**CITY OF AUSTIN
Board of Adjustment
Decision Sheet**

CASE NUMBER: C16-2018-0006

ADDRESS: 1165 AIRPORT BLVD

Entry Monument (Removable) Proposed Signage

Entry Monument (Removable) Structure and Design

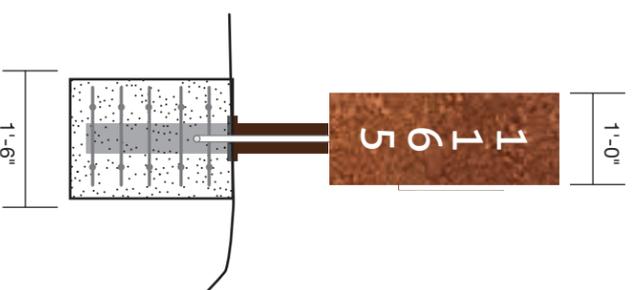
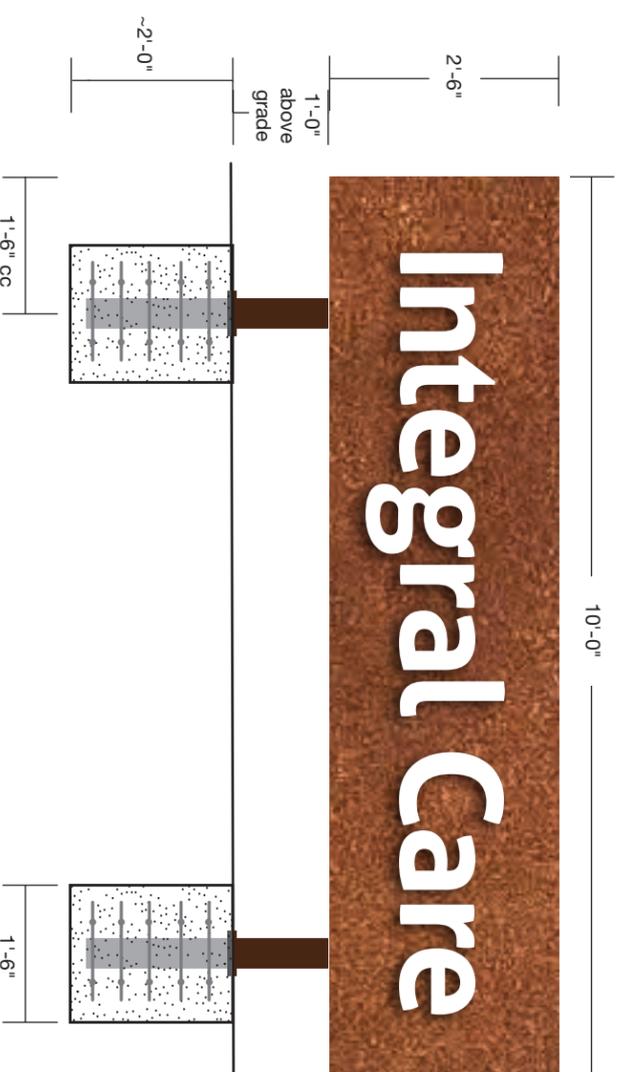
Eben Kellogg, property agent for COA and I (Albert), from Capital Architectural Signs, agreed on a solution that satisfies all utility access requirements by utilizing a removable or temporary sign closest to the property line with at least 10'-0" clearance from utilities in lieu of a permanent monument sign.

A. Concrete Foundation: 1'-6" planked concrete above grade; ~1'-0" direct embed with #4 rebar @ 12" O.C.; ~2'-0" footing with #4 rebar @ 18" O.C; T & B, each way.

B. Illumination: bright white LEDs mounted inside cabinet faces and returns; connected to power supplies others to run main electrical via conduit. Must coordinate prior to pouring of concrete form .
